## Sigurnosna obavijest

***Urgent Field Safety Notice for:  
Dako Autostainer Instruments (AS480; AS100; S3800; S3400):***

**Update of Autostainer Link Basic User Guide to reduce risks of staining issues due to leakage**

#### “Instrument leakage inspection

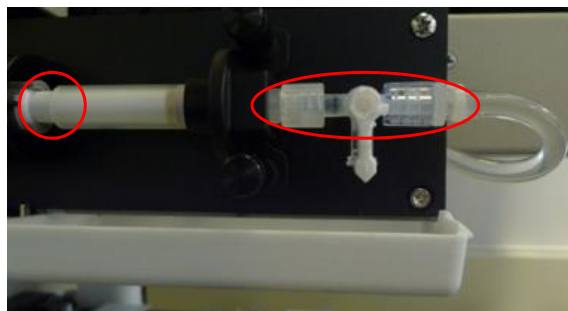
- **New section below has been added regarding inspecting the instrument for signs of leakage** (Table in “Cleaning and Maintenance Guideline Summary”, in English version: page 180, and in subsection “Instrument Leakage Inspection”, start of subsection in English version: page 186)

Visually Inspect the left plate, and the area around the wash station for salt residues and/or liquid, see pictures below. If there are signs of unexpected salt residues and/or liquid, contact your local Agilent Technical Service representative as this might indicate a leakage in the liquid system. If leakage is observed, the slides from the run just completed must be closely reviewed for staining abnormalities.”

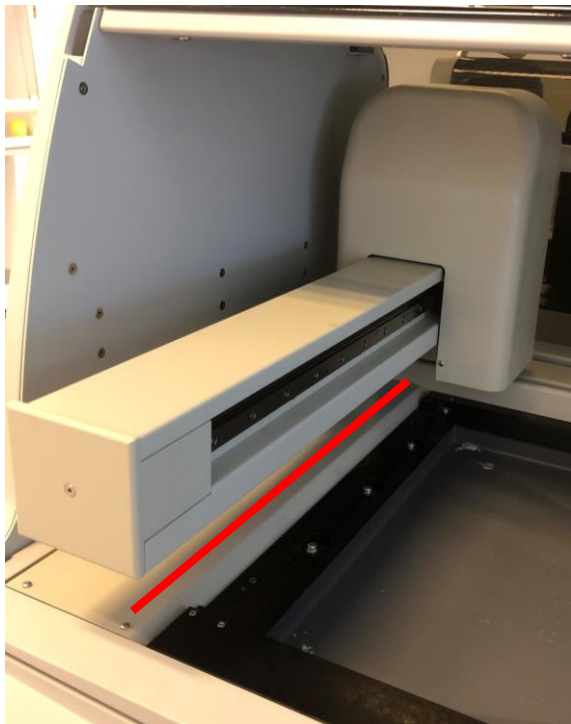
Visually inspect the syringe tray, syringe and stopcock, areas highlighted in red, for signs of unexpected leakage (salt residues and/or liquid).

Visually inspect the left plate, area highlighted in red, for signs of unexpected leakage (salt residues and/or liquid). This might indicate leakage from the robotic arm.

Visually inspect the area around the wash station, area highlighted in red, for signs of unexpected leakage (salt residues and/or liquid). This might indicate leakage from the z-head or too high pump pressure.

**WARNING** Leakage from the robotic arm or z-head may impact staining quality. Do not use the instrument if there are signs of unexpected leakage (salt residues and/or liquid), or if you observe leakage.
